**OBJECTION RESPONSE ON 2018/3810**  
**HAMPTON COURT STATION & JOILLY BOATMAN SITE REDEVELOPMENT**  
**HAMPTON COURT RESCUE CAMPAIGN RESPONSE**  
**ON URBAN DESIGN & HERITAGE ISSUES**

1. This objection response document has been prepared on behalf of Hampton Court Rescue Campaign to address specific issues on Urban Design and Heritage only, and should be read alongside other objection submissions on our overall concerns, our parking study response, and other issues.

1.1 This is an aerial photo with the site outlined taken from the application documents

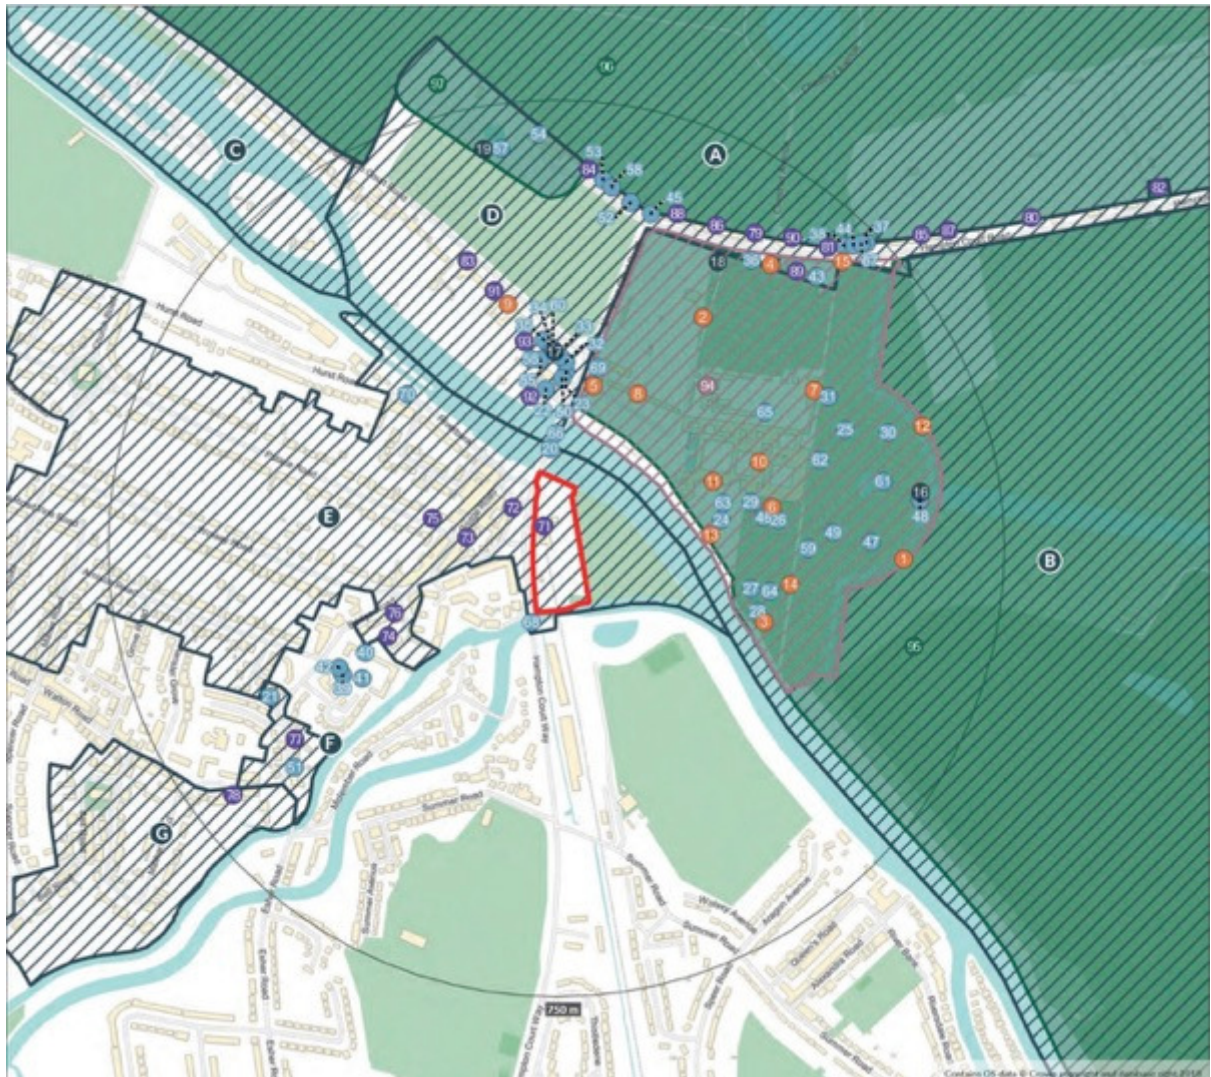
- Operational railway land with a surface car park, together with a vacant site on ex railway land that once contained a small single storey café, plus a small car sales site;
- It is on the edge of a unique village around Bridge Road and Creek Road which has a strong sense of place;
- It is surrounded by open land to the east which separates Molesey from Thames Ditton and forms two riverside open spaces;
- It sits at the edge of the River Thames, and adjacent to the Lutyens listed Bridge, and forms the foreground to the historic Hampton Court Palace which is of international importance;
- It is a complex site and I'm familiar with the planning history of the site, the 1999 Planning Brief and the 2008 approved scheme;

- A brownfield site; the majority of the site is still in use. The Jolly Boatman part of the site originally contained a demolished single storey building on approximately one tenth of the area;
- It's not in a town centre, nor a district centre, and it's outside the Bridge Road Local Centre;

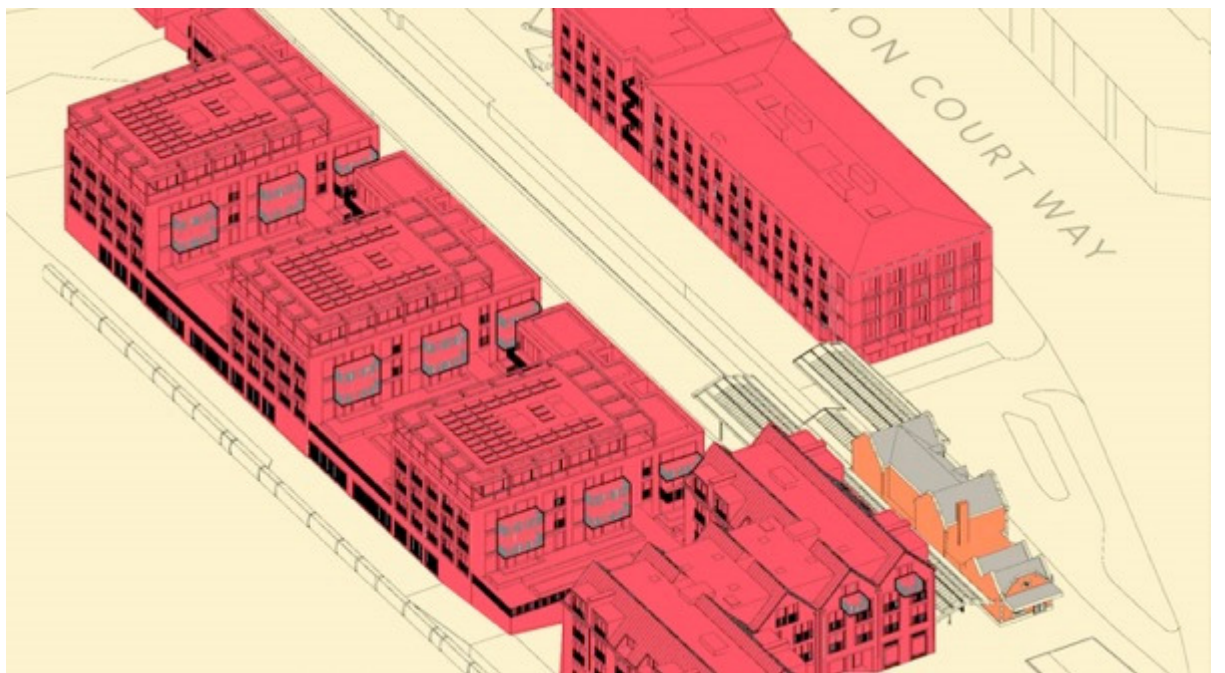
- 2.3 Looking at these historic photos we can see the station today is basically the same structure, although it has suffered some alterations and loss of architectural features since the 1970's. The application does not present any restoration proposals for the station, nor does it demonstrate the reuse of the ground, first or 2<sup>nd</sup> floor internal spaces. This is simply unacceptable, as such a major development should at a minimum demonstrate it is enabling restoration of the retained historic building. A restoration scheme was part of the 2008 approval.

- 2.10 If the station is listed, and I do not know how long the decision will take, there would be a statutory duty on the Council to preserve the setting of the station

- A. That officers should make representations to Historic England for a swift decision on the listing application and that**
- B. The Council should delay consideration of a decision on this application until a listing decision is received.**

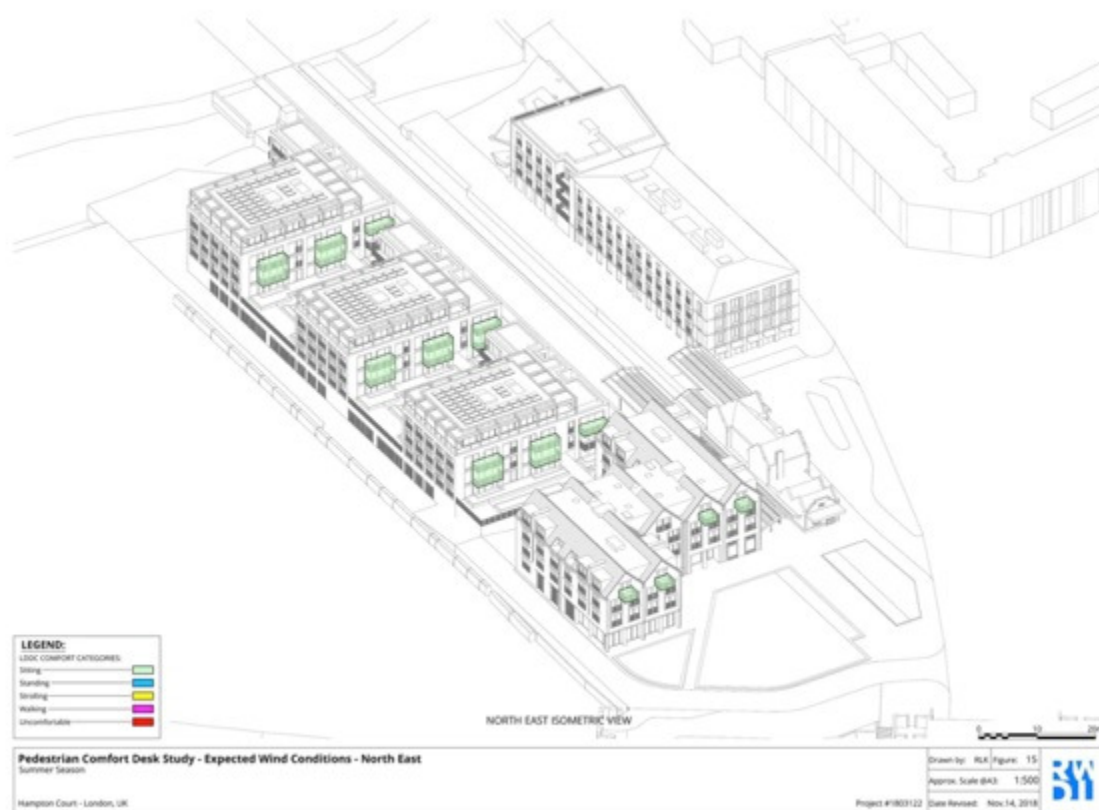
- 3.6 Three videos have been produced by a HCRC member using the applicant's 3D drawings from other documents that I hadn't looked at. The videos were then made into one compilation shown in my presentation. I can only produce three stills from the videos here to demonstrate what is not found in the Design Statement. The videos are found on our website and have been distributed to Members.

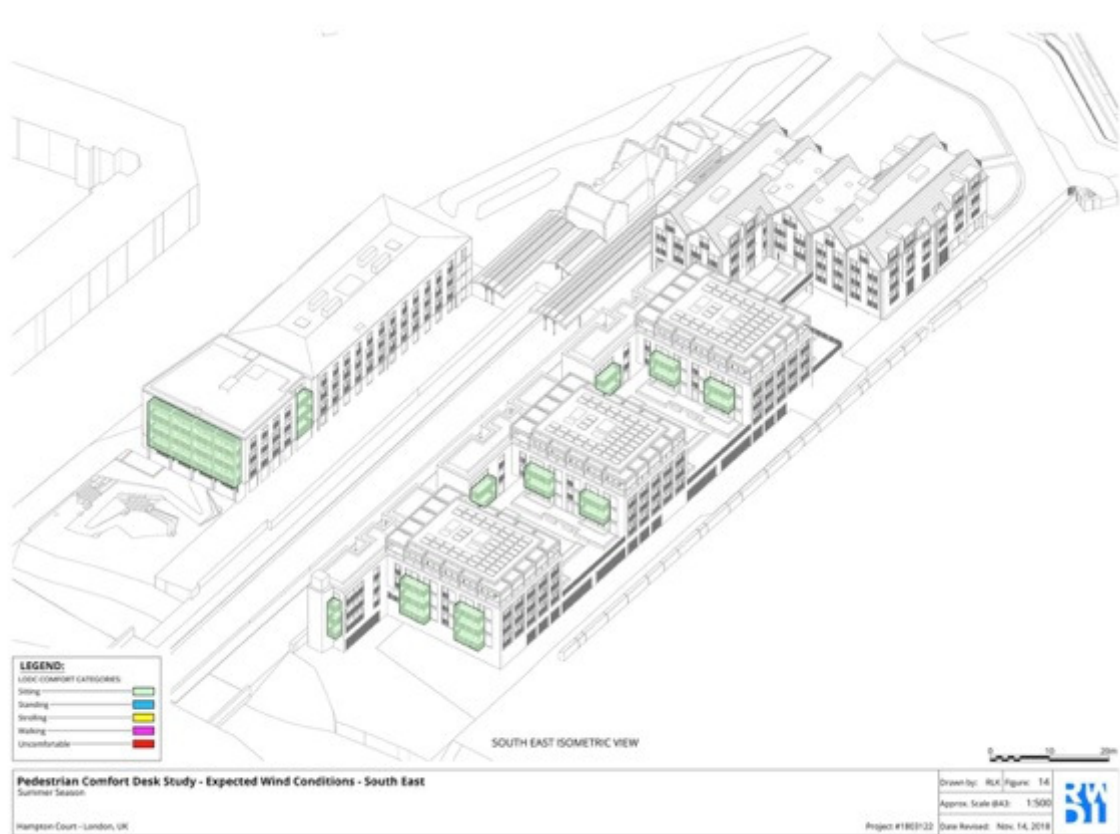
3.8 This one starts to show the context with the surrounding buildings, look just how big the blocks are compared to even the largest Hampton Court Parade building. The floor plan is nearly twice the depth.

3.9 This one starts to show the excessive size of the blocks north of the railway line, comprising the 3 villas and the riverside building in comparison with the many smaller block bounded by Creek Road and Bridge Road which is roughly a similar size.

3.10 This one shows the three building blocks simply within the context of the surrounding village. The 3 villas and the riverside block fill a space greater in size than the whole of the Creek Road and Bridge Road block which comprises about 30 buildings or more.

**3.14 Our Request is that Officers advise the applicant that the Special Planning Committee will need an architectural model of the proposal in its surroundings, together with computer generated 3D modelling images before this application is presented to Committee.**

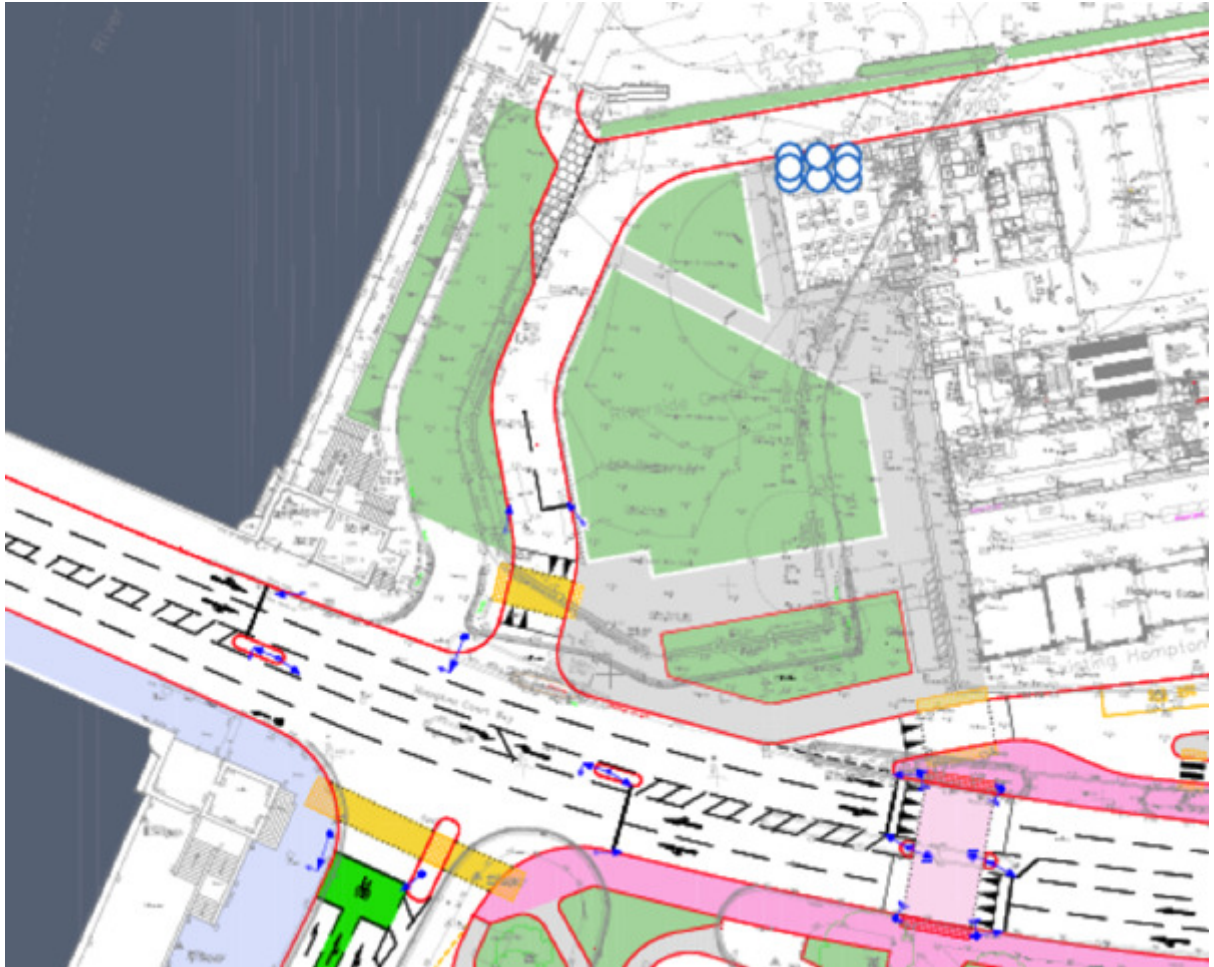
6.2 The landscape master plan shows new areas of open space near the river, and a large z shape block of more residential with a retail and café unit. The sole access to the site runs through this space. It involves repositioning the park maintenance access road owned by Surrey County Council, and we have concerns that this commercial development is being facilitated by public land.

6.3 This open space extract shows four pieces of green, fragmented by the main access road and pedestrian paths. It is not a space that could be conceived as a Square. The materials list shows upstands around the lawns presumably to protect users from vehicles. The bank down to the mooring platform, located inside the railings, is included in the site which is probably environment agency land. The black metal railings were put up in the 1950's, and not as part of the 1930's bridge work and lock the bank so that it cannot be maintained. It is full of self-seeded trees that need to be removed and the space together with the extremely narrow pedestrian, path annotated as 8, need to be incorporated into the open space, with the railing relocated to the mooring platform retaining wall. This is not a detail that should be subject to a condition.

6.4 Looking at the highway layout we can see the landscape plan conveniently forgets to show a set of traffic lights, a raised table and a drop off layby on this access road. No doubts there will be much signing clutter too. We think this will be a hazardous space to use and will be visually fragmented and cluttered. This is how we think it will look.

6.5 We consider it is **not** a user-friendly space, it is dominated by traffic and has no connectivity to the existing park. The open space has some visual merits, but it does not meet our long-term objectives of linking the river, the bridge and the pedestrian routes to the park both visually and functionally.

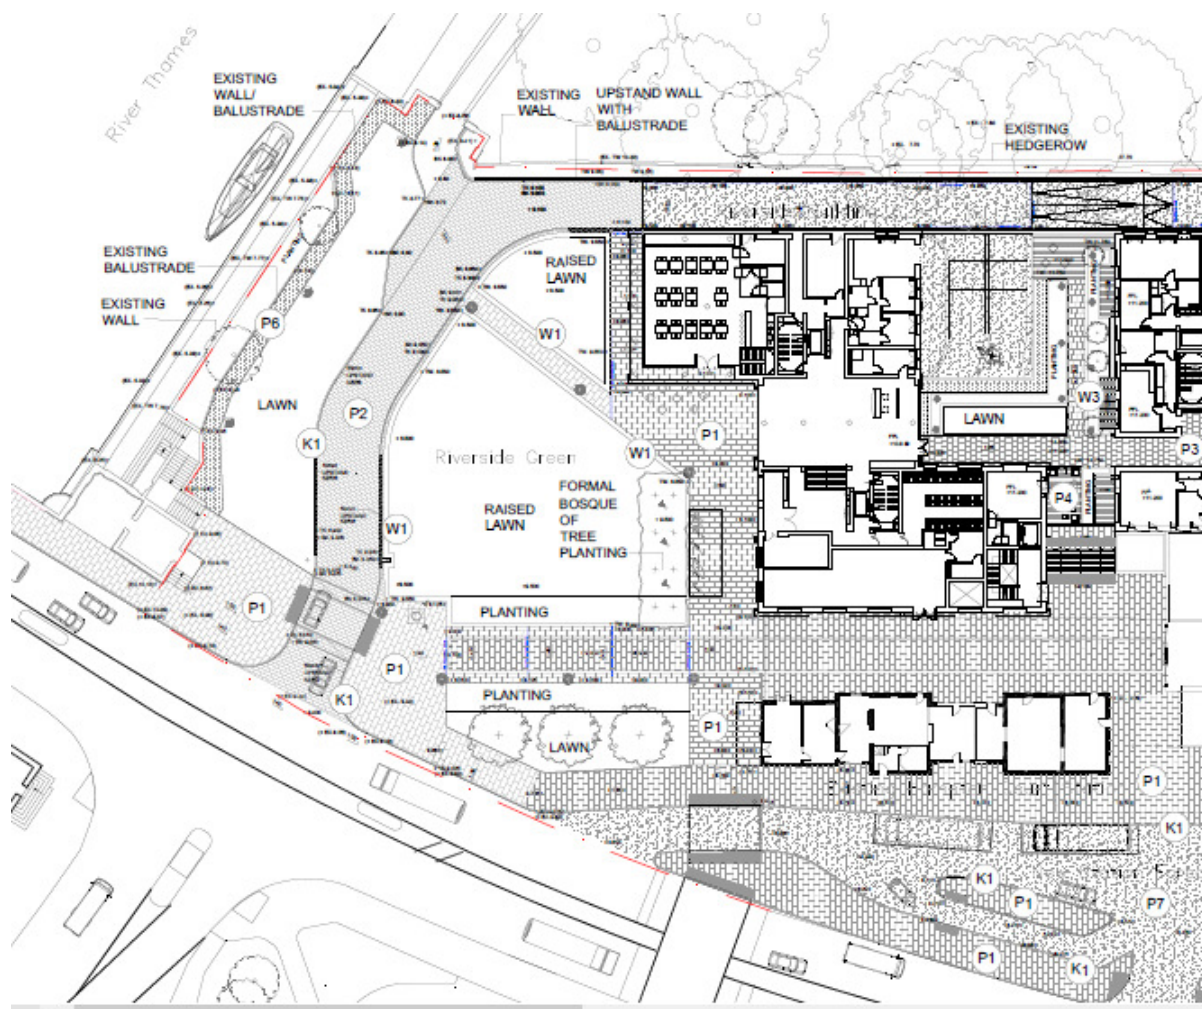
6.6 The access road positioning and levels are determined by the basement car park ramp beneath this space and result in the access road being set at least 1m above the existing levels and floating above the park. This requires a new retaining wall with balustrading which is not shown on the Landscape Master Plan or in any images including the CGI or colour perspectives. The open space is shown as a neat flat area but it will have a one metre ramp across it, which then dips down to the access road along the hedge, in which there is a pedestrian access gate into the public park. This is a visual nightmare, and a high-risk pedestrian route. See the images below from the submitted documents.

6.7 See the annotation for existing wall along the park boundary adjacent to the Lutyens obelisks and path entrance. This is a 1950's derelict graffiti covered wall of no interest containing window openings that should be removed to open up the views of the park. A new "Upstand wall with balustrade" is annotated within the application site leaving a landlocked gap. The levels around the walls and raised road have not been given due regard in relation to the park. The park at the pedestrian gate in the hedge is on average 7.8m AOD, and at the barrier entrance at the Lutyens obelisks it is 8.2m AOD. The proposed access road is at 9.1m AOD within 300mm of these adjacent lower levels. Thus, the road needs an upstand retaining wall to hold back the 1-1.3m difference in land. This is going to be a visual block to the park whereas it has been expressed to the developers by HCRC and HRP that the objective is to open up views of the park for visual and functional improvements.

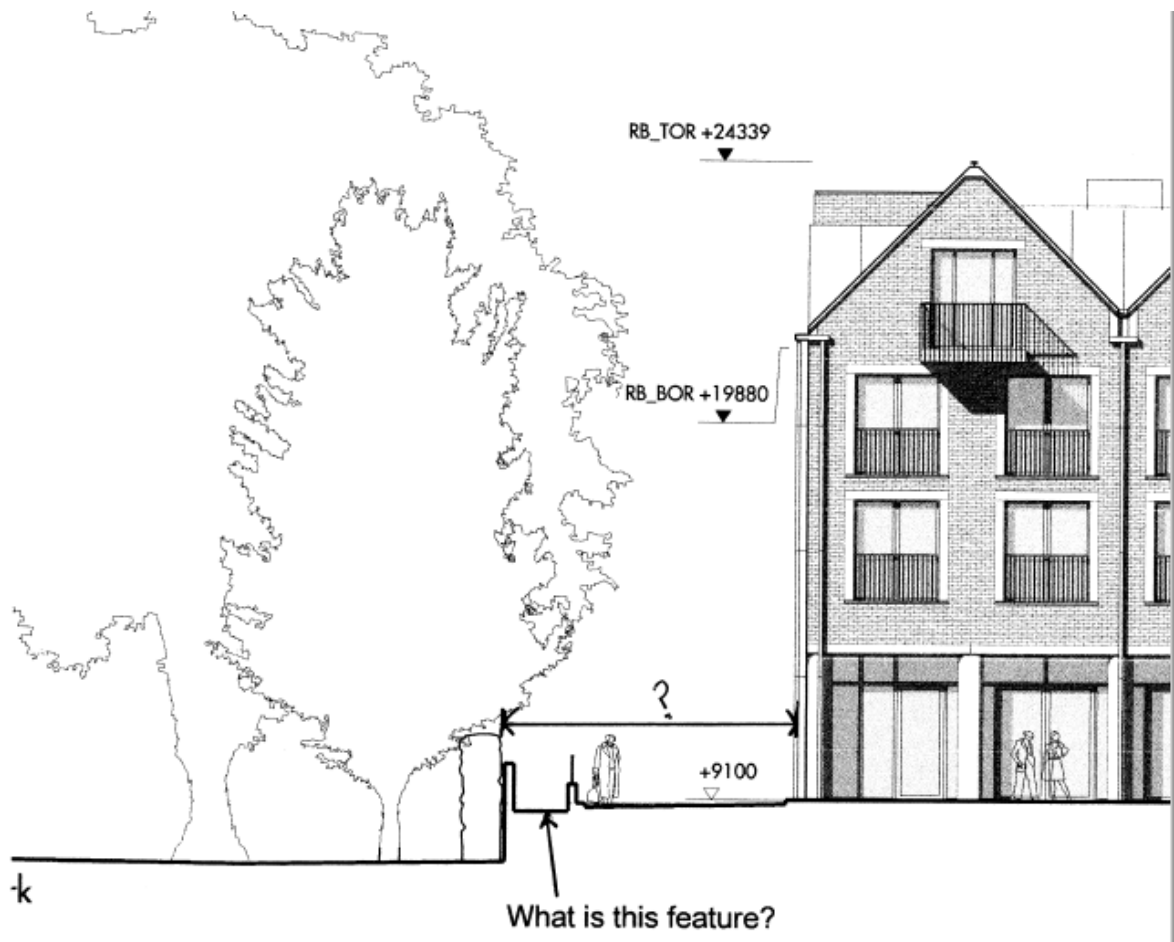
6.8 This is the applicants amended elevation and access road section showing the dead piece of land between the two walls. Note the existing hedge will no doubt be lost to construct the temporary car park, and the close proximity to the mature trees, the canopy of which overhangs the access road must put the trees at risk. This open space proposal does not safeguard our public park, and will definitely isolate it further.

**6.12 Our Request is that we ask the Council to agree that the that the new square has a limited contribution both visually and functionally, that it is set at a raised level that is determined by the basement car park design, so that it will not relate to the adjacent park. The riverside building enclosing the open space is poorly conceived to the detriment of the setting of the station, the listed bridge, and the Kent Town Conservation Area.**
